- I. The Proposed Changes to Technical Specifications
- II. Justification and Safety Evaluation
- III. Analysis of Significant Hazards Consideration

Attachment II

Technical Justification and Safety Analysis

CONTAINMENT PRESSURE CONTROL
SYSTEM LOGIC
FIGURE II-1

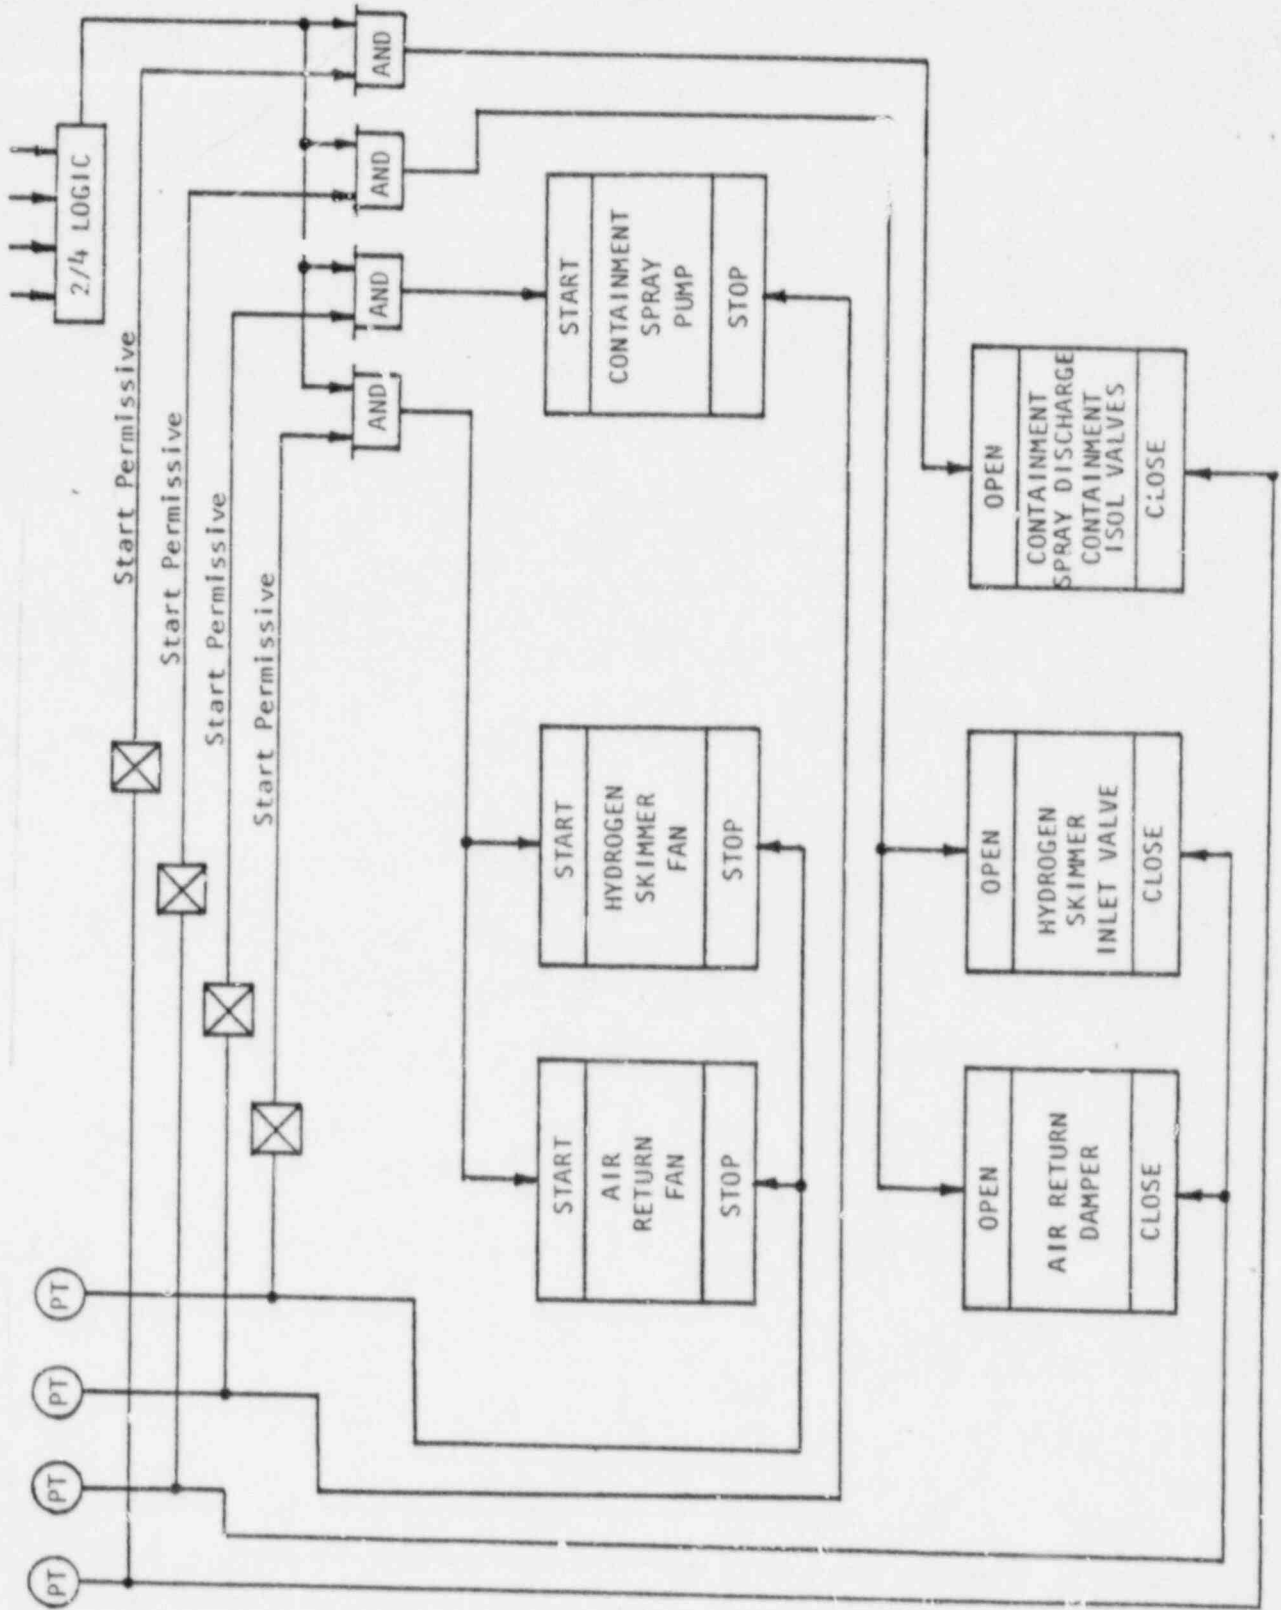
Item 6 of Table 3.3-3 lists the CPCS as having 4 channels per train with 2-out-of-4 trip logic and at least 3 channels required to be operable. However, each of the four channels has a different function in the operation of the CPCS. Each of the pressure switches provides a start permissive/termination signal to one or two of the following components: Containment Spray (NS) Pump, Air Return Fan (VX), Hydrogen Skimmer Fan, Air Return Damper, Hydrogen Skimmer Inlet Valve, and NS Isolation Valves. Therefore, in order to assure proper operation of the CPCS, all four

channels must be operable. Table 3.3-3 is being revised to reflect that there are two trains of 4 channels each, and that all eight channels are required to be operable, or the affected system (Containment Spray or Containment Air Return/Hydrogen Skimmer as applicable) must be declared inoperable and actions taken pursuant to the appropriate Technical Specification. The Action Statement, which requires that any inoperable channels be placed in the "Start Permissive" mode, will ensure that the components required to control containment pressure will be available when needed. See Figure II-1 for CPCS Logic.
